FRANKLIN FACADE

NEWBURY FACADE

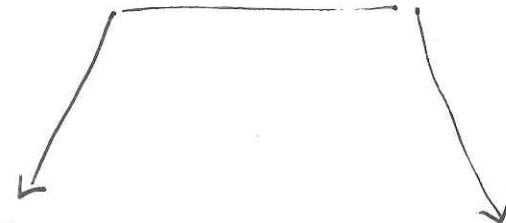
- Lighting + landscaping could activate Franklin facade
- In general, carry materiality of upper floors down to garage level
 - cladding material brought lower
 - two indentations brought down to ground
 - windows added to top garage level
- Base material more similar to rest of architectural palette in color

Emphasize corner w/ more height

Bring material down slightly
